1978 - 1979 Corvette: Service Bulletin: Glass Roof Panel Trim Separation

Subject: Glass Roof Panel Trim Molding Separation

Number: 79-T-7

Date: April, 1979

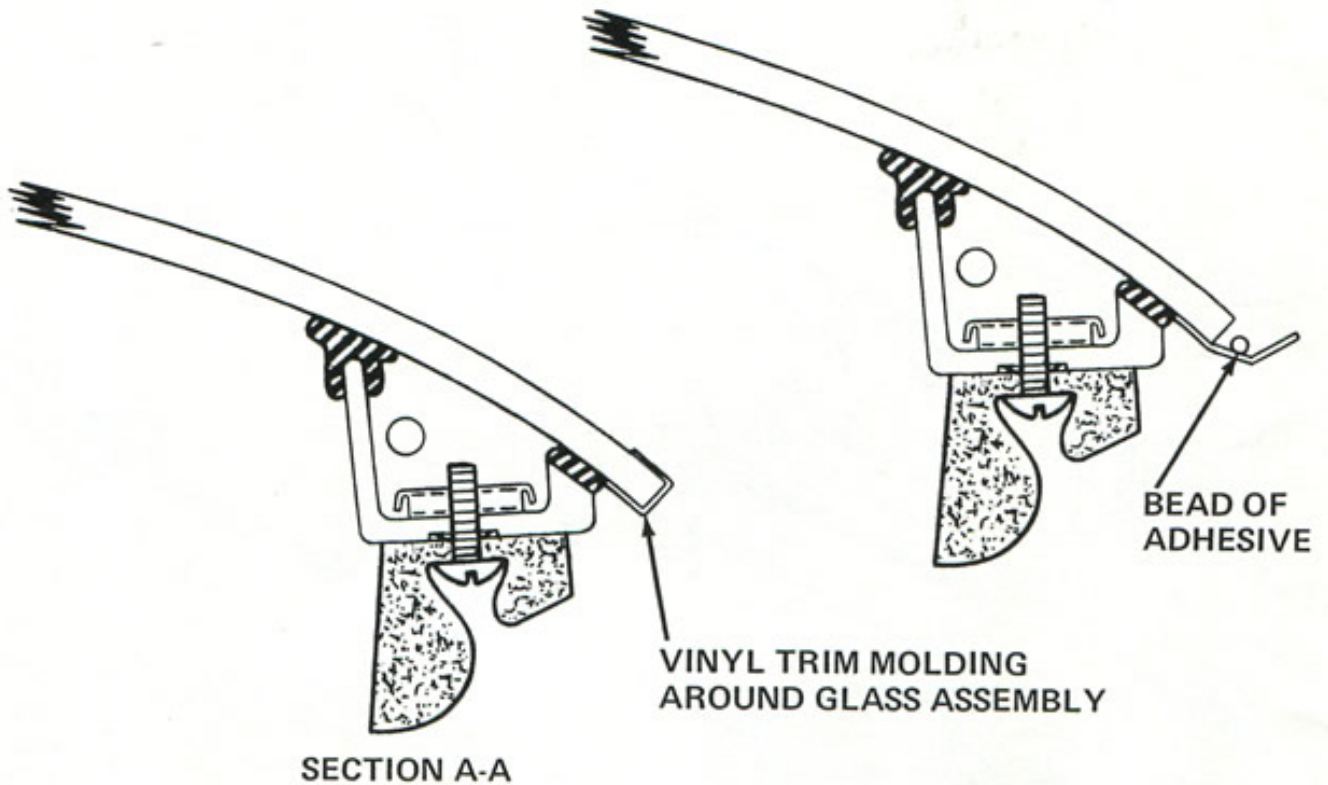
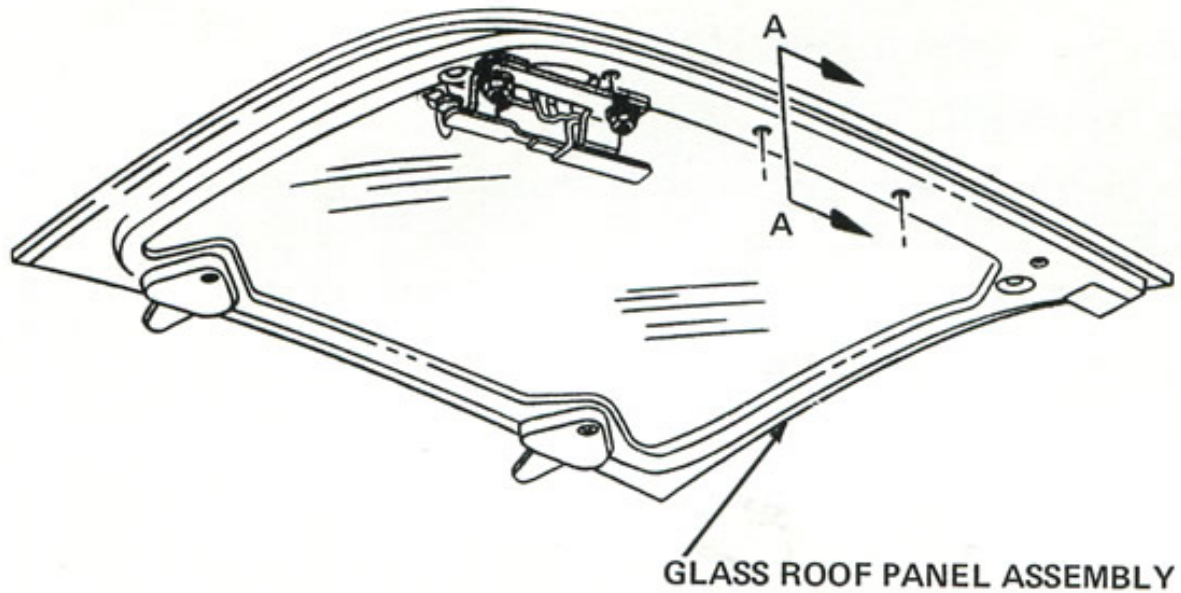
A few 1978-79 Corvettes equipped with the RPO CC1 glass roof panel may exhibit the condition of the vinyl trim molding separating from the glass panel.

The recommended service correction is application of a two part epoxy, such as 3M P/N 8640, or equivalent between the glass panel and the molding.

1. Remove the roof panel from the vehicle, but do not separate the glass from its frame.
2. In the area to be bonded, clean both the molding channel and glass thoroughly with a dry cloth to remove dirt and loose adhesive.
3. Mix epoxy as directed on package. Note cautions and curing time.
4. Transfer the adhesive into a small plastic bag ("baggie") and twist to push the adhesive into a corner. Cut off this corner to provide the proper bead size of approximately 1/16 inch diameter.
5. Apply a 1/16 inch diameter bead of adhesive into the molding channel, as illustrated, and place the channel firmly over the glass edge, allowing the excess adhesive to squeeze out.
6. After the "squeeze out" becomes firm, remove it carefully with a dull blade.
7. Allow approximately one hour cure time at room temperature before

reinstalling the roof panel.
